FINDLAY CITY PLANNING COMMISSION

STAFF REPORT January 14, 2016

Thursday, January 14, 2016 - 9:00 AM

OHIO LOGISTICS II BUSINESS PARK

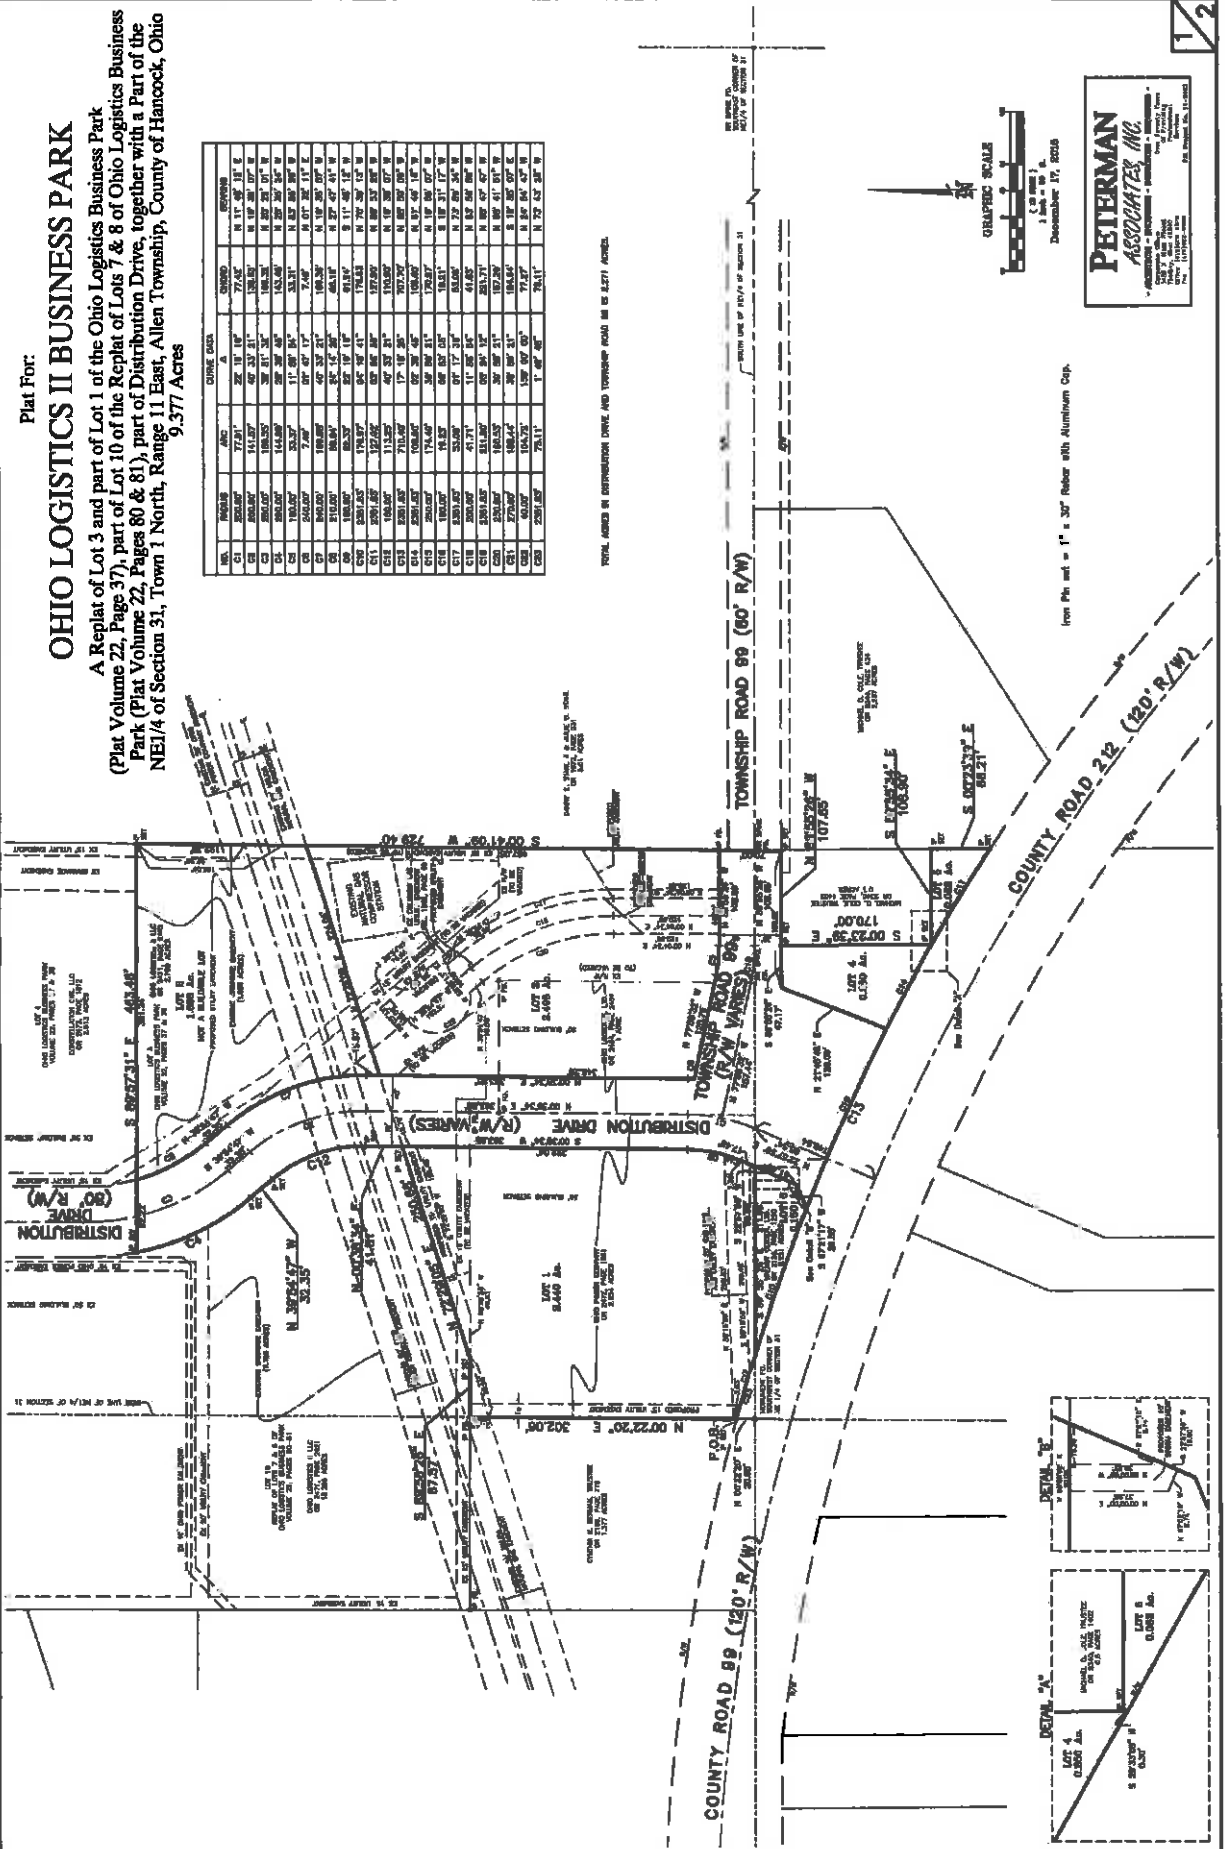
There are labels for the building setbacks on the lots but the setback lines are not shown.

Shouldn't the heading and legal description also include part of the SE1/4 of Section 31?

- **Show setback lines for the lots (ENG)**
- **Correct legal description is necessary (ENG)**

Proposed Dimension Plan

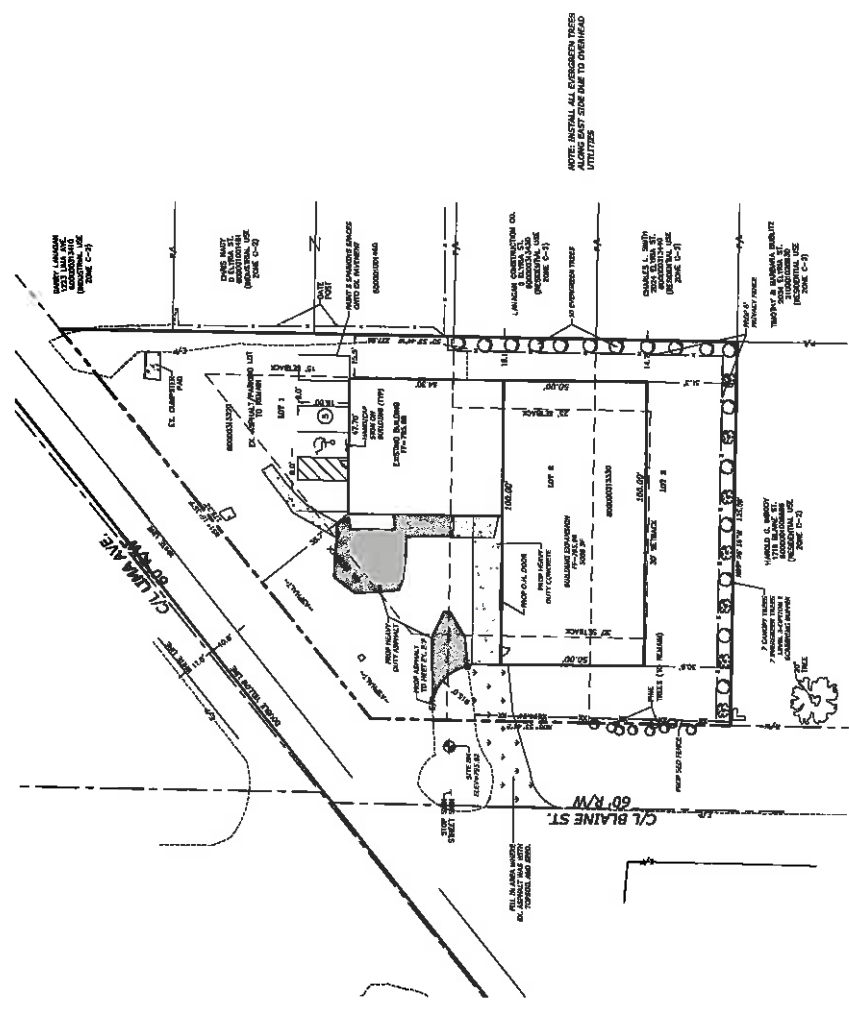
Setbacks are an issue also in either zoning district. The I-1 district has larger setbacks than the C-2 district. The layout submitted shows the setbacks for C-2 but the building does not fit within those boundaries either. The building encroaches into both side yards. This will also require a variance if the request to expand the non-conforming use is approved.

The curb cut onto Blaine Avenue is being removed. Access will be from Lima Avenue only. Currently the Lima Avenue side is a continuous open asphalt area from the street. Engineering may wish to see some more controlled access for the site.

There are existing residences to the south and the east half of the property. Screening is shown with 6' privacy fencing and landscaping. The rear line has canopy trees as well as evergreens on the outside of the fence. Along the east side only evergreens are shown with the notation that there are overhead utility lines that would be an issue with tall deciduous trees.

Access – The site currently has a drive on Blaine Street and a second drive along Lima Avenue. The applicant is proposing to remove the drive on Blaine Street and make no changes to the drive on Lima Avenue. The existing drive on Lima Avenue is approximately 180 feet wide and includes the entire frontage of the property. While it can be difficult to get delivery vehicles into and out of smaller sites like this one, having the entire frontage along Lima Avenue as one large curb cut seems excessive. Engineering believes that it should be possible to have 2 smaller drives spaced so that delivery vehicles would still be able to enter/leave the site.

- The consultant work with Engineering to reduce the width of the existing drive along Lima Avenue.
